**RE: 232 Danville Drive**

I reviewed the drawings and evaluated the site context. My comments and recommendations are as follows:

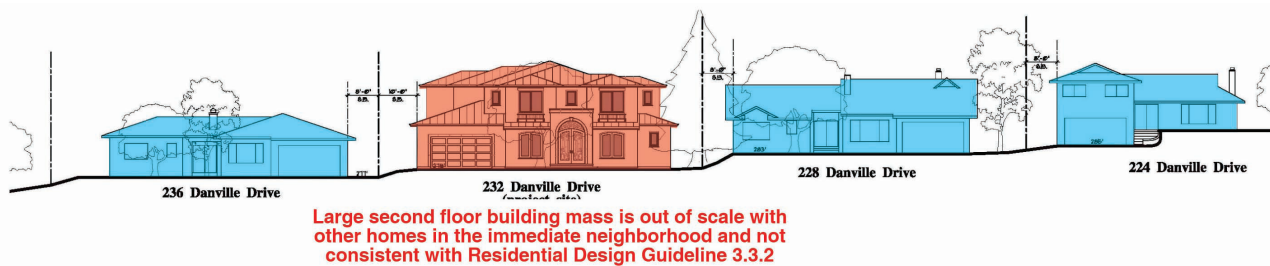
The proposed house is well designed with design unity around all sides of the structure. However, it is very large in terms of size and bulk compared to homes in the immediate neighborhood which is not consistent with several of the Town's Residential Design Guidelines. Specific concerns include the following:

1. The home design is consistent with the main form and details of its selected Mediterranean Style, but is very much different from the surrounding Ranch Style homes which would not be consistent with Residential Design Guideline 3.2.1.

2. The large second floor building mass is out of scale with other homes in the immediate neighborhood, and not consistent with Residential Design Guideline 3.3.2.

### 3.8.2 Select materials that are sensitive to the surrounding neighborhood

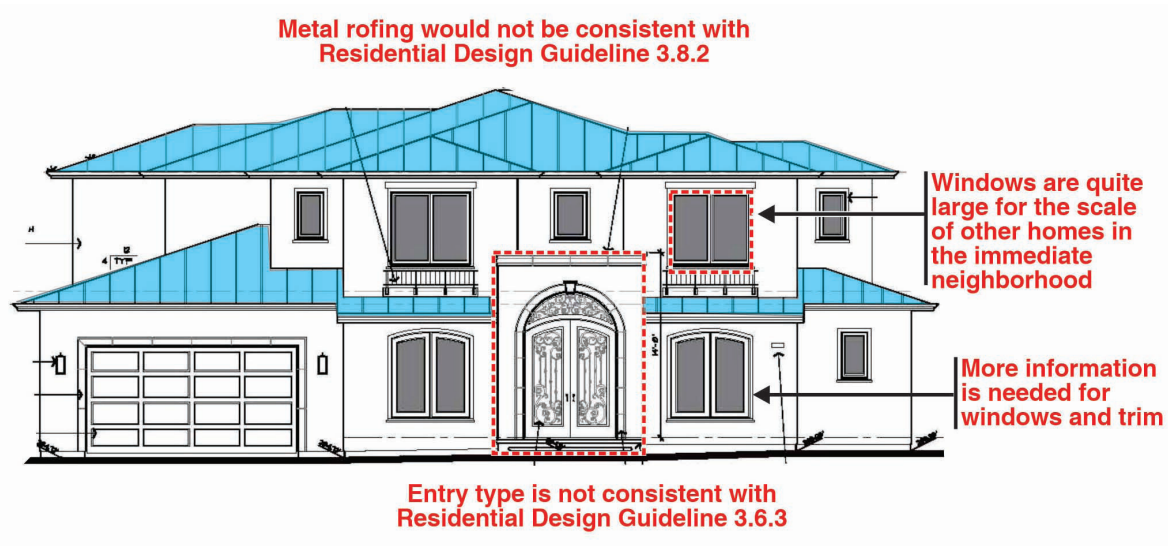
3. The proposed metal roofing would be out of character with the neighborhood and not consistent with Residential Design Guideline 3.8.2.

1. Select a roof material that is more similar in color, texture and finish to other homes in the immediate neighborhood.
2. Provide an under-the-eave entry to be similar to the other home entries in the immediate neighborhood.
3. Reduce the size of the front facade windows on the second story.
4. Provide more information on the window types, material and trim.
5. Extend the roof overhang on the left side and rear elevations to break up the tall walls.

**3.3.3 Provide visual relief for two story walls**

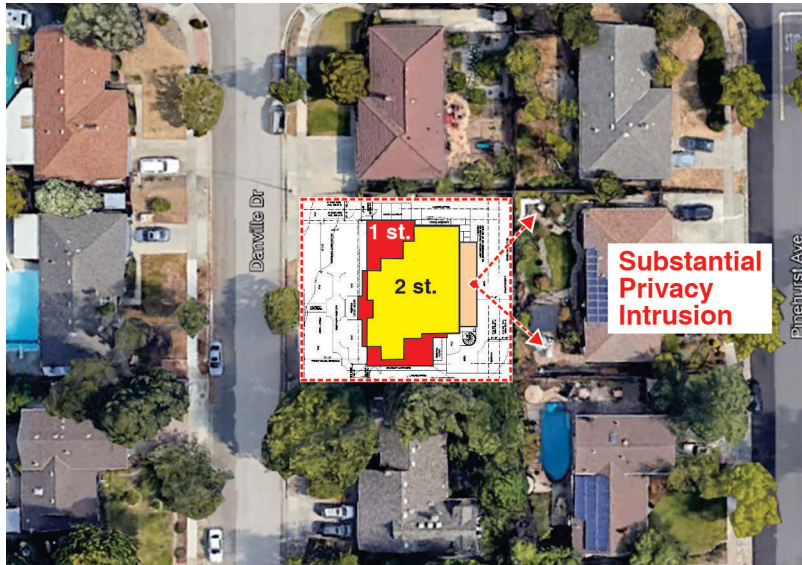
7. The two-story wall on the left facade is not consistent with Residential Design Guideline 3.3.3.

**Rear second floor terrace poses substantial potential privacy intrusion on adjacent neighbor's private outdoor space and is not consistent with Residential Design Guideline 3.11.2**

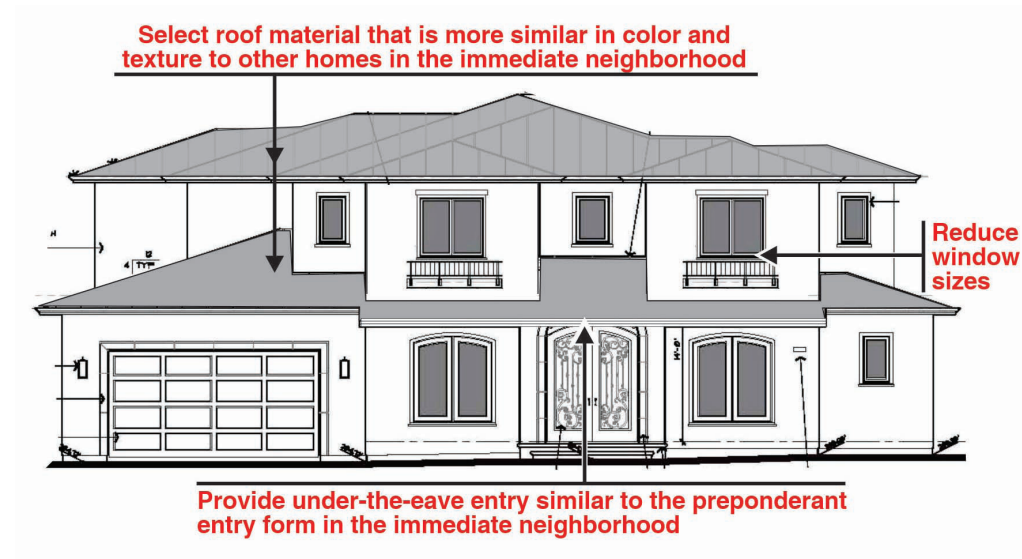
8. The rear second floor terrace and large bank of windows poses potential privacy intrusions on the neighbors' yard to the rear.
